Tuesday, July 19, 2022

McFarland Municipal Center
Community Room

AGENDA

AGENDA ITEM: Discussion and possible action on Resolution No. 2022-11, a Resolution Approving Planned Development Infill District-Detailed Plan for Phase 2 of the Atwater Development, 4719 Farwell Street, McFarland, requested by Lakestone Holdings LLC.

4721 FARWELL STREET DEVELOPMENT
PROPOSED SITE PLAN
SHEET: C-2
DATED: JULY 6, 2022

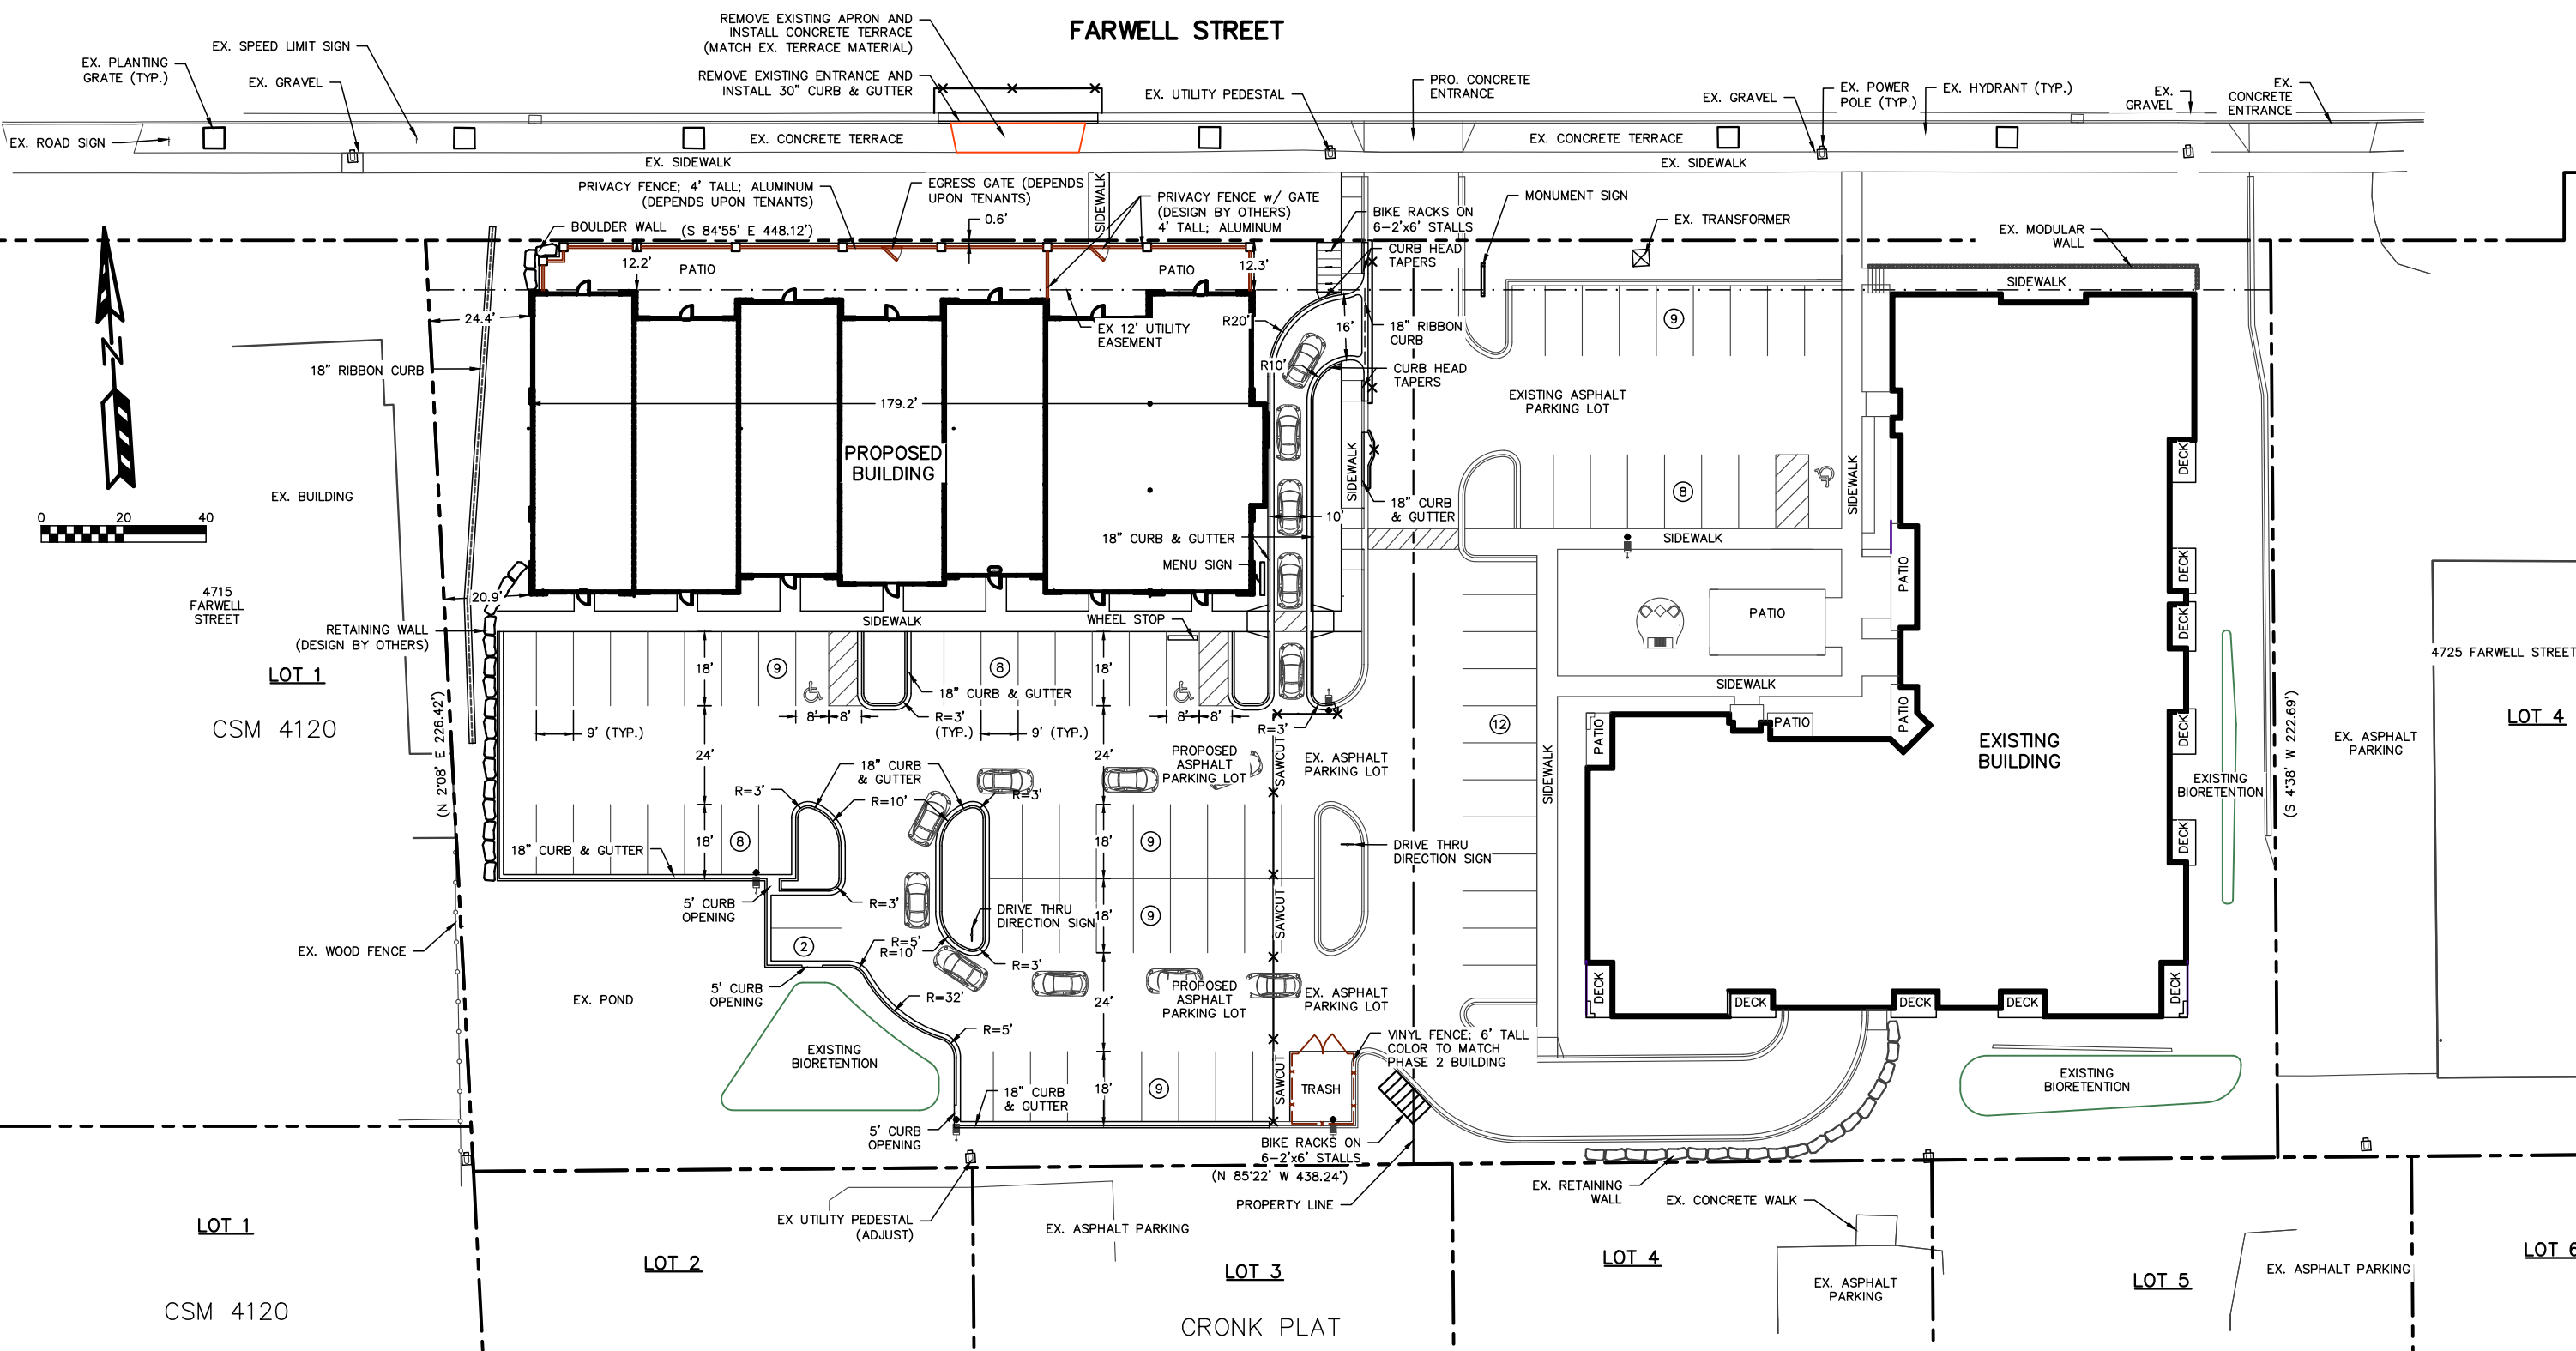
Lakestone Properties submitted revised site plans (dated July 6, 2022) that included adding a drive thru menu board (refer to Sheet C-2) and permanent patio fencing (refer to Sheet A900). The Applicant has indicated it is their intent to install the entire perimeter front patio fencing at time of building construction. Staff expressed some concern with the limited space within the drive thru lane to stack vehicles at the two service points (menu/order board and pick-up window) without blocking the crosswalk or causing potential congestion with vehicles entering and exiting the parking stalls. While the July 6 site plan illustrates five vehicles in the drive thru lane, in staff's opinion, only three vehicles can stack from the pick-up window to the start of the drive thru lane. Given these concerns, Lakestone developed two site plan alternatives (Alternatives 1 and 2), which are included in the packet for Plan Commission consideration. Staff has recommended a slight variation of Alternative 2 (Alternative 2B) which is included in the packet for consideration, which is estimated to allow approximately 7 vehicles to stack from the pick-up window to the start of the drive thru lane, with a trade-off of losing three on-site parking stalls.

4721 FARWELL STREET DEVELOPMENT
PROPOSED SITE PLAN
SHEET: C-2
DATED: JULY 14, 2022

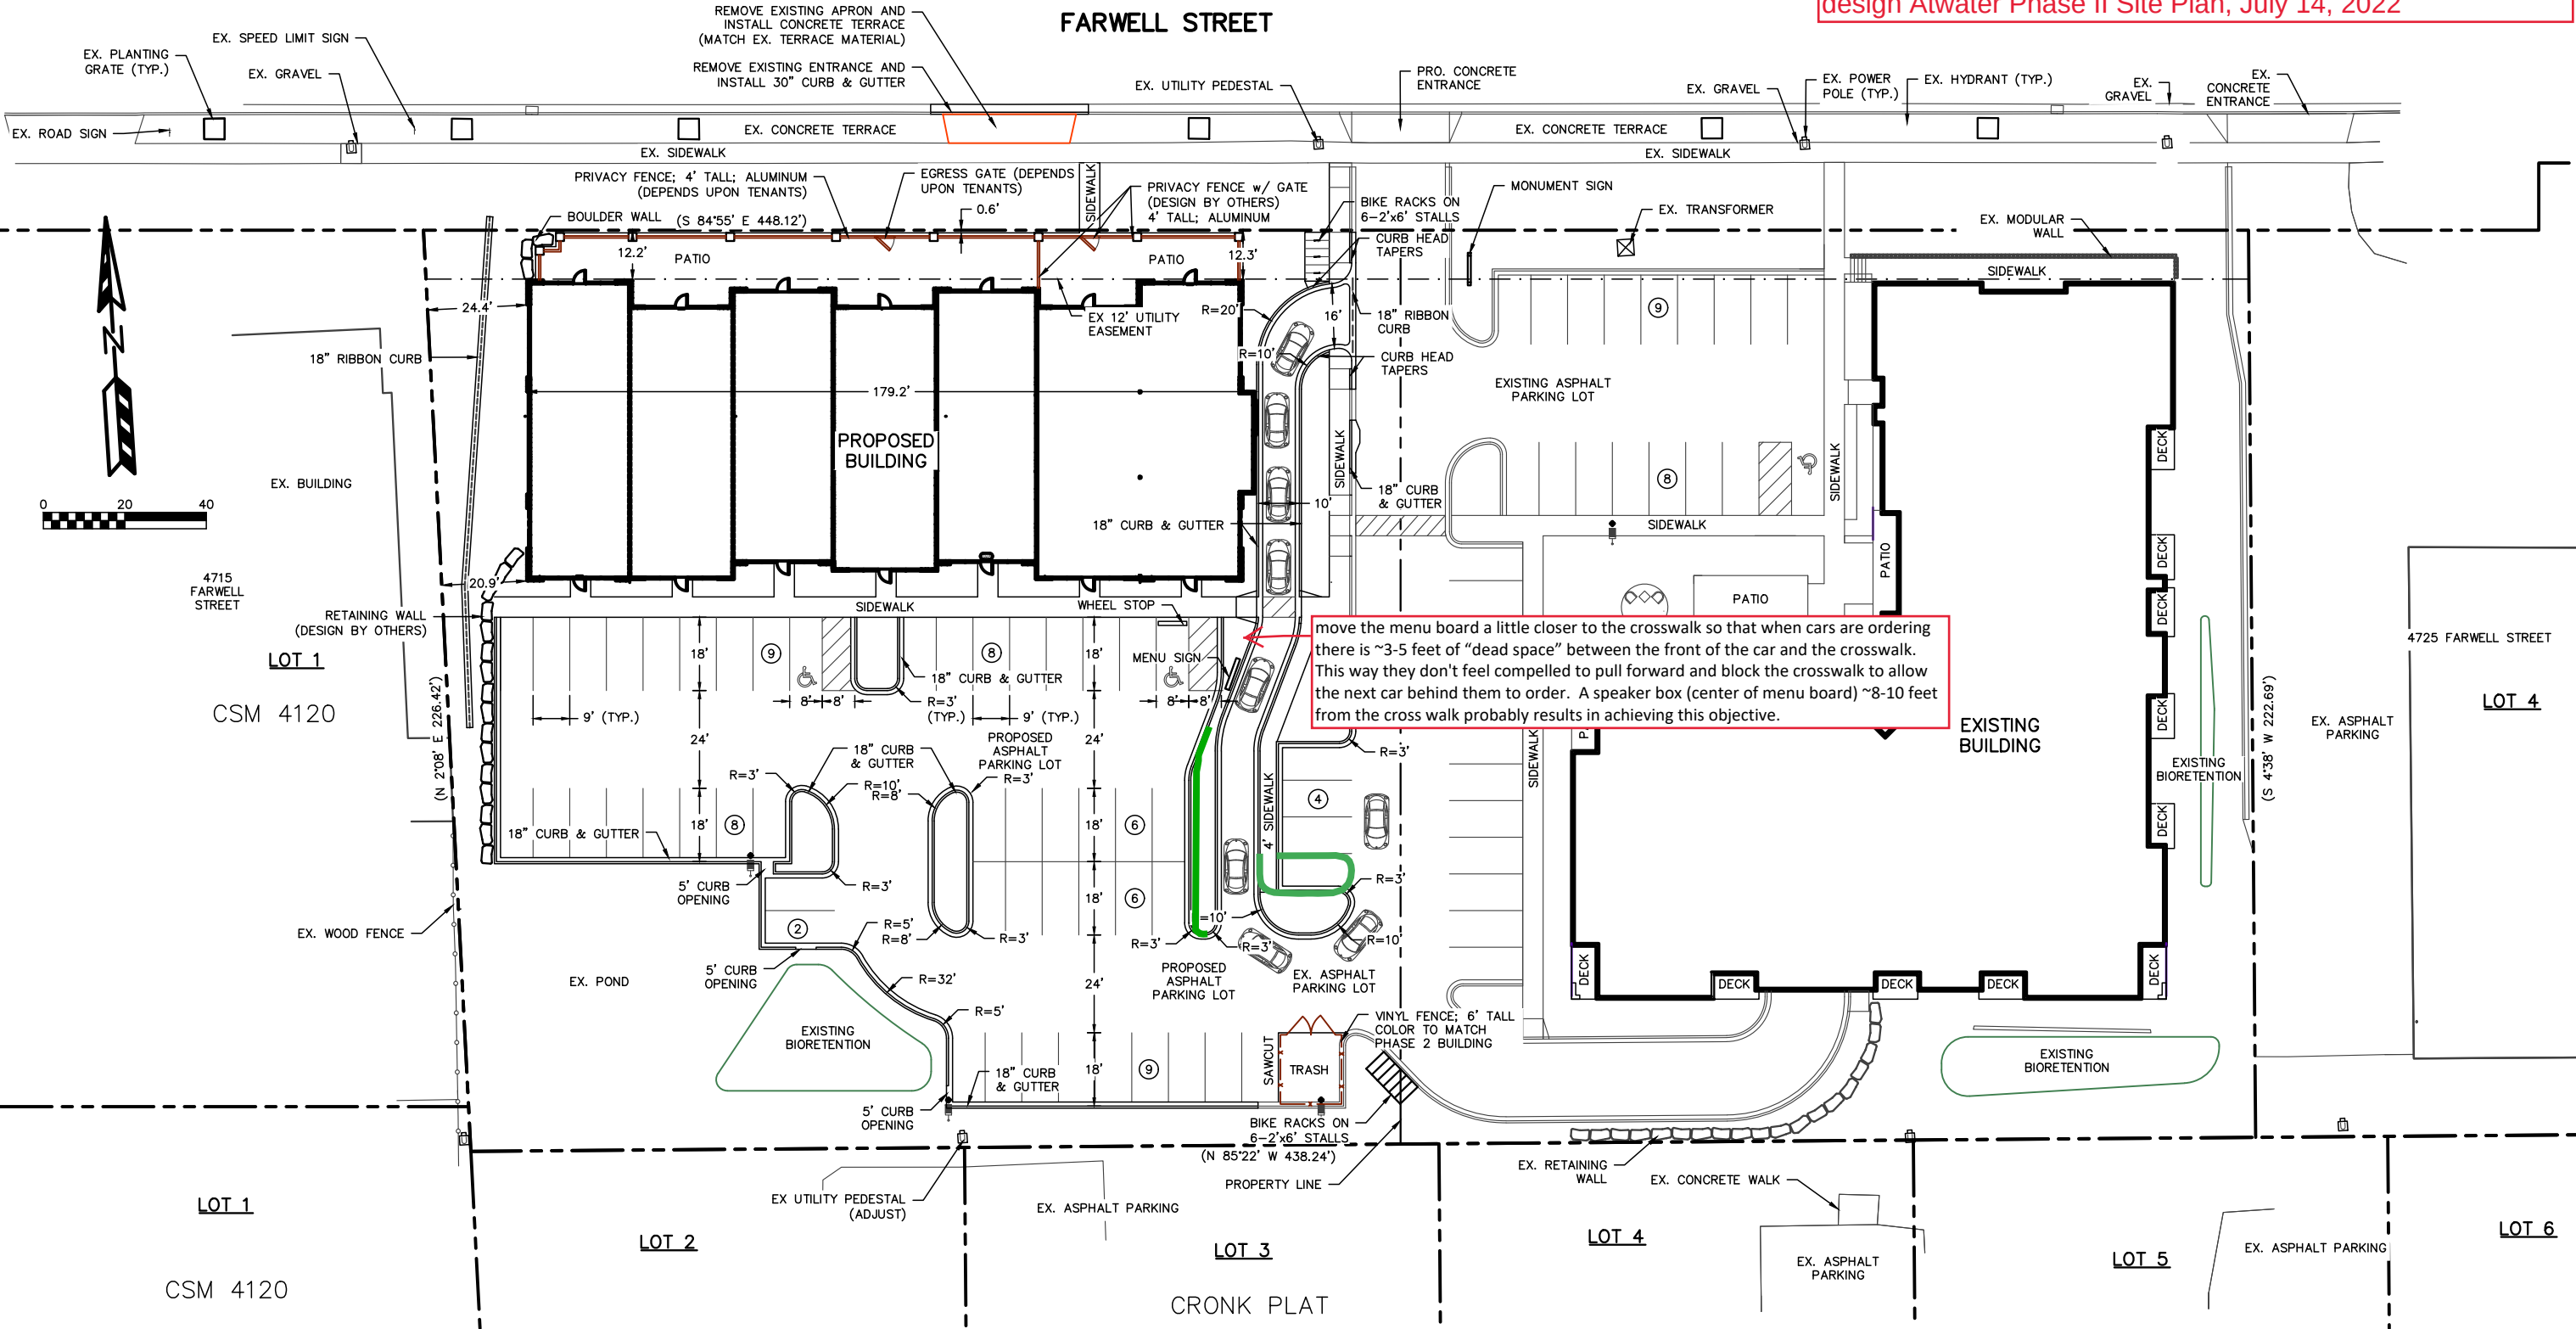
Drive Thru Alternative 2B - Community & Economic
Development Staff notes regarding preferred drive-thru site design Atwater Phase II Site Plan, July 14, 2022

6. Applicant to revise site plan sheets to reflect proposed drive thru Alternative 2B as conceptually shown in the Community & Economic Development's copy of the proposed site plan, dated July 14, 2022.
